Subject: UniStar Nuclear Energy, NRC Docket No. 52-016
Response to Request for Additional Information for the
Calvert Cliffs Nuclear Power Plant, Unit 3,
RAI 279, Ultimate Heat Sink

**Response to NRC Request for Additional Information RAI No. 279,
Question 09.02.05-7, Ultimate Heat Sink,
Calvert Cliffs Nuclear Power Plant, Unit 3**

NRC Question 09.02.05-7

Figure 9.2-3— {Normal Makeup, Emergency Makeup, Blowdown & Chemical Treatment}
(Typical for each of 4 independent trains)

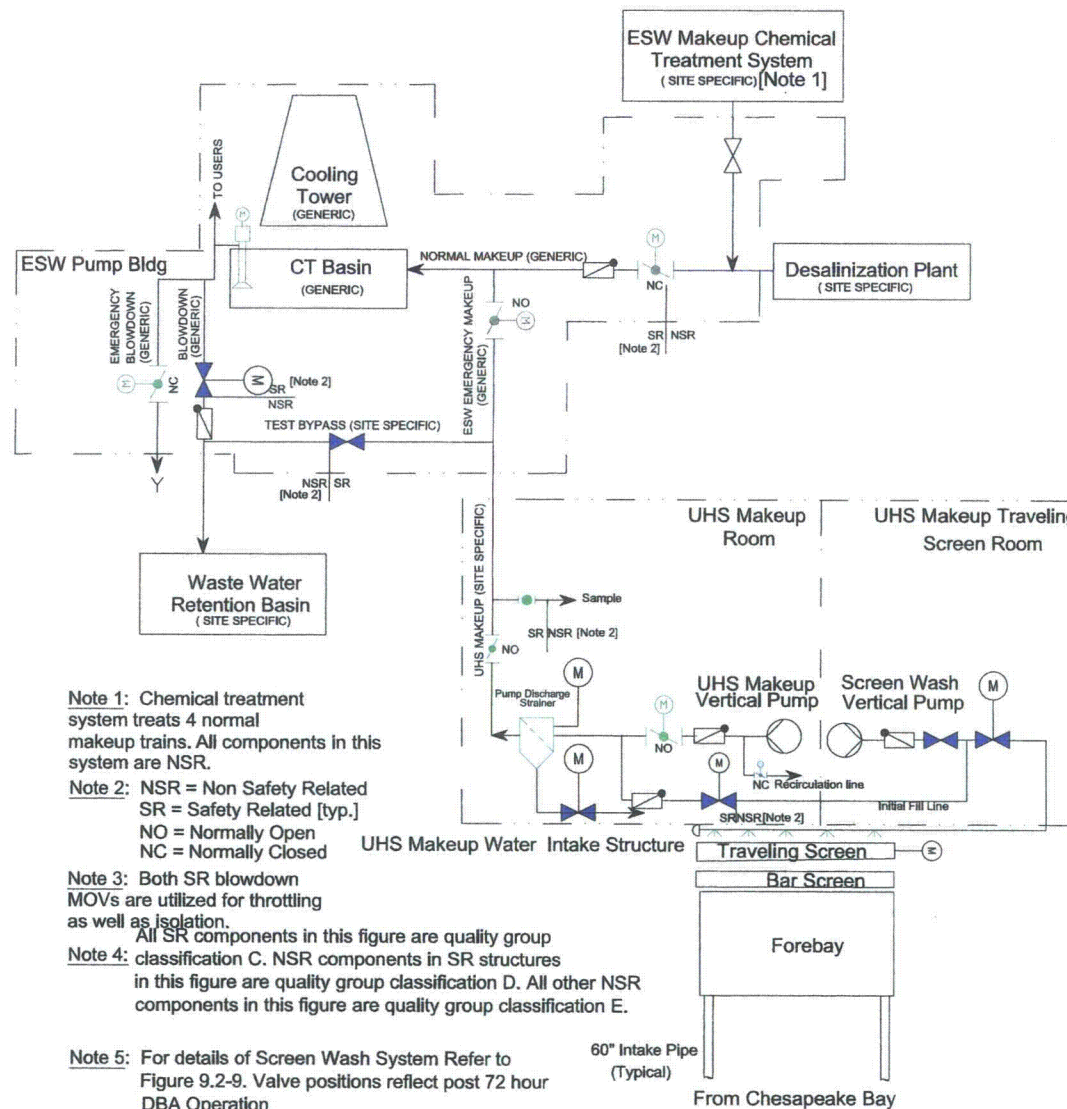
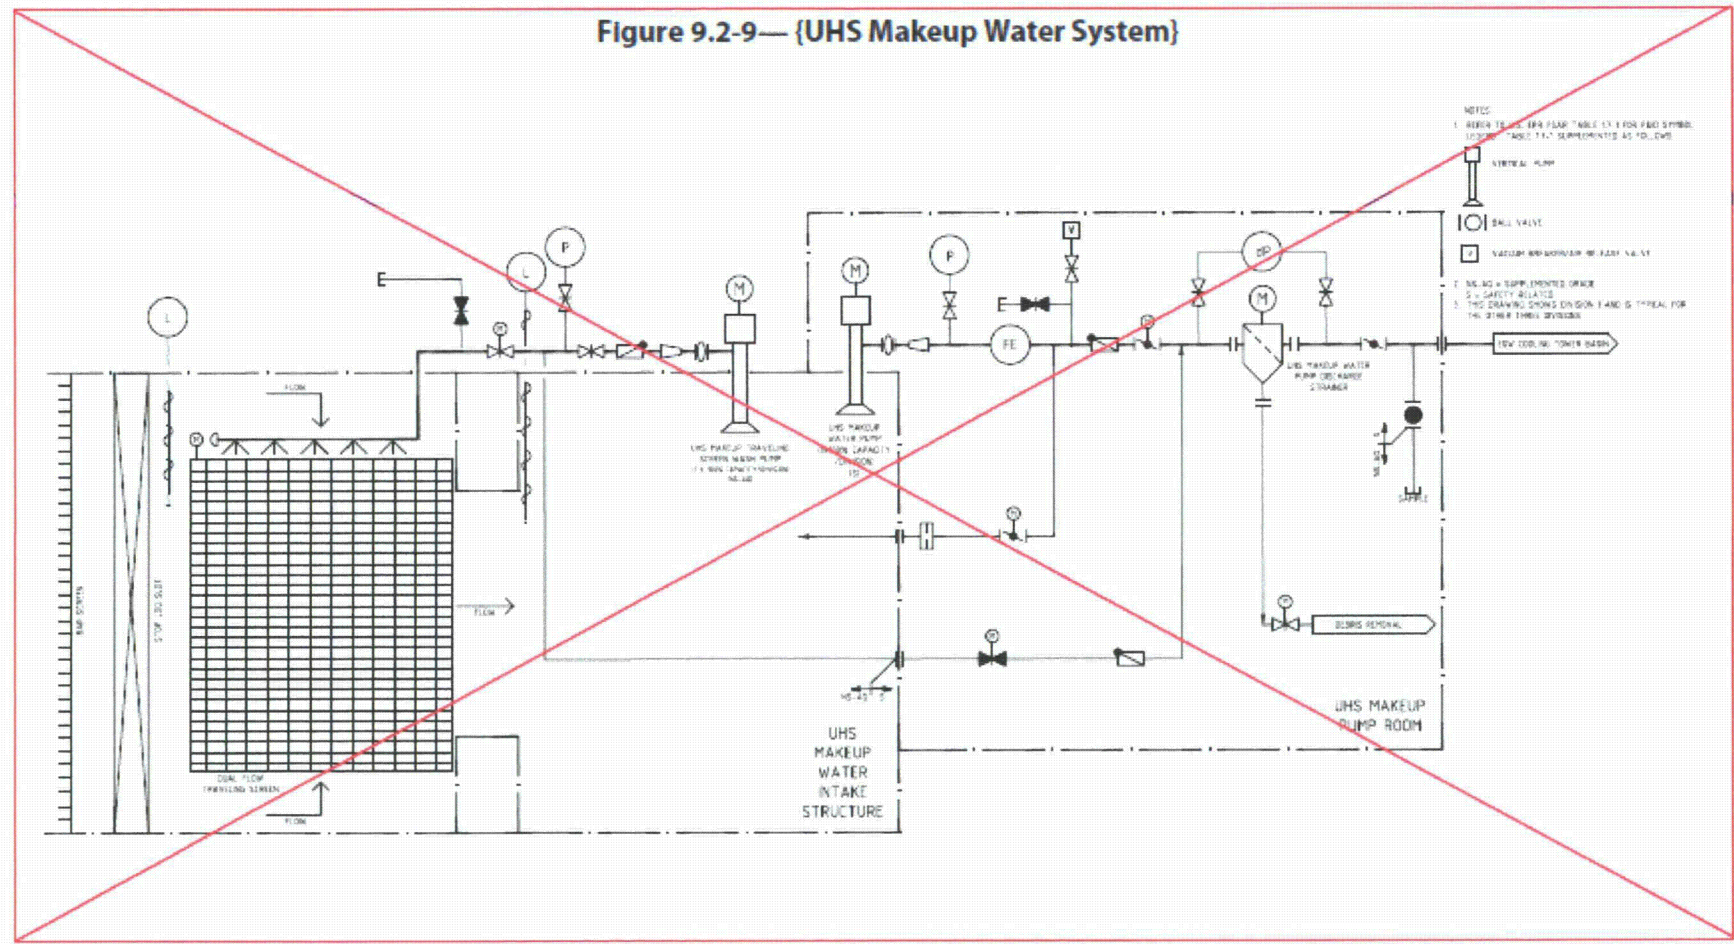
- Pipe sizes are not shown on FSAR Figure 9.2-3, "Normal Makeup, UHS Makeup, Blowdown & Chemical Treatment," and the system description in Section 9.2.5 does not explain the criteria that were used in establishing the appropriate pipe sizes (such as limiting flow velocities).

- FSAR Figure 9.2-3 does not show the location of indications (e.g., local, remote panel, control room, remote shutdown panel), and does not identify the instruments that provide input to a process computer and/or have alarm and automatic actuation functions.

- FSAR Figure 9.2-3 does not identify the normal valve positions, the valves that are locked in position, and the valves that have automatic functions. These design features are not described in FSAR Section 9.2.5. When FSAR Figure 9.2-3 is compared to U.S. EPR FSAR Figure 9.2.5-1, "Ultimate Heat Sink Piping and Instrumentation Diagram," the drawings do not appear to match up with respect to boundaries for the normal makeup and UHS makeup.

- FSAR Figure should be corrected to agree with the U.S. EPR DCD FSAR Figure 9.2.5-1. FSAR Figure 9.2-3 safety related components, for example motor operated valves (MOVs), are not labeled with identification numbers.

- FSAR Figure 9.2-3 shows safety related MOVs that appear to be not located in any safety related buildings and possibly buried. Clarify the exact locations of all safety related components for the UHS.

- FSAR Figure 9.2-3 does not show the screen wash system or travelling screens.
- FSAR Figure 9.2-3 refers to an alternate blowdown line and the EPR FSAR Figure 9.2.1-1 refers to an emergency blowdown line. Determine if the terminology should be changed to be consistent, or indicate that these are different piping systems.

- FSAR Figure 9.2-3 should label the "UHS makeup" line as essential service water system (ESWS) emergency makeup to be consistent with Section 9.2.5.
- FSAR Figure 9.2-3 is incorrect and does not show the ESWS pumps at the UHS basin. It appears the blowdown piping system is off the UHS basin and not on the ESWS pump discharge; this should be corrected in FSAR Figure 9.2-3.

- FSAR Figure 9.2-3 does not show strainer MOVs as described in Table 8.1-1 through Table 8.1-4, "Division 1,2,3,4 Emergency Diesel Generator Nominal Loads."

- FSAR Figure 9.2-3 shows a safety related motor operated valve for the sample; however, it is not described in detail if this valve has a logic signal to close on an accident signal.

- FSAR Figure 9.2-3 shows a chemical addition pipe directing flow to the suction of each UHS makeup pump. Describe the installation of this piping system related to seismic supports and effects on the UHS makeup pumps during a seismic event.

CCNPP Unit 3 COLA FSAR Figure 9.2-3 is a conceptual figure to provide information on the interfaces of UHS Makeup Water system with the Essential Service Water (ESW) system. Figure 9.2-9 depicts level of instrumentation and controls consistent with the figures in the U.S. EPR FSAR. UHS Makeup Water flow rate, pressure, differential water level across screens, strainer differential pressure, open or closed valve position status and energized or de-energized pump operating status are available in the main control room (MCR) for the operation of the system.

CCNPP Unit 3 COLA FSAR Figure 9.2-3 is a conceptual figure to provide information on the interfaces of UHS Makeup Water system with the Essential Service Water (ESW) system. The piping and components outside the ESW pump building are part of the site-specific design. CCNPP Unit 3 COLA FSAR Figure 9.2-9 will be revised to show position indicators on the valves. The CCNPP Unit 3 COLA FSAR Figure 9.2-3 shows the open and closed position of the valves during a design basis accident. Position indicators for the valves that are inside ESW pump building are part of generic design shown in US EPR FSAR. CCNPP Unit 3 COLA FSAR Figure 9.2-3 will be revised to match the boundary of normal makeup and UHS Makeup with respect to U.S. EPR FSAR Figure 9.2.5-1. The design features of the UHS Makeup Water System will be updated as described in the response to Question 09.02.05-7 (Bullet No. 3).

CCNPP Unit 3 COLA FSAR Figure 9.2-3 and Figure 9.2-9 depict information on the screen wash system and traveling screens.

CCNPP Unit 3 COLA FSAR Figure 9.2-3 will be revised to show as "EMERGENCY BLOWDOWN" replacing the terminology "ALTERNATE BLOWDOWN" for the portion of piping inside ESW pump building.

CCNPP Unit 3 COLA FSAR will be revised to clarify the description on Figure 9.2-3.

The conceptual CCNPP Unit 3 COLA FSAR Figure 9.2-3 provides an overview of the UHS Makeup Water system and its interface with the standard plant design. FSAR Figure 9.2-3 will be revised to reflect the appropriate level of detail.

CCNPP Unit 3 COLA FSAR Figure 9.2-3 will be revised to depict the UHS Makeup Water pump strainer MOVs. The debris removal system (UHS Makeup Water Strainer) backwash arm operates similar to a valve operator, as such it is classified as a motor operated valve in Table 8.1-1 for the purpose of classification of electrical loads.

FSAR Figure 9.2-3, "{Normal Makeup, Emergency Makeup, Blowdown & Chemical Treatment}" is being revised as follows:
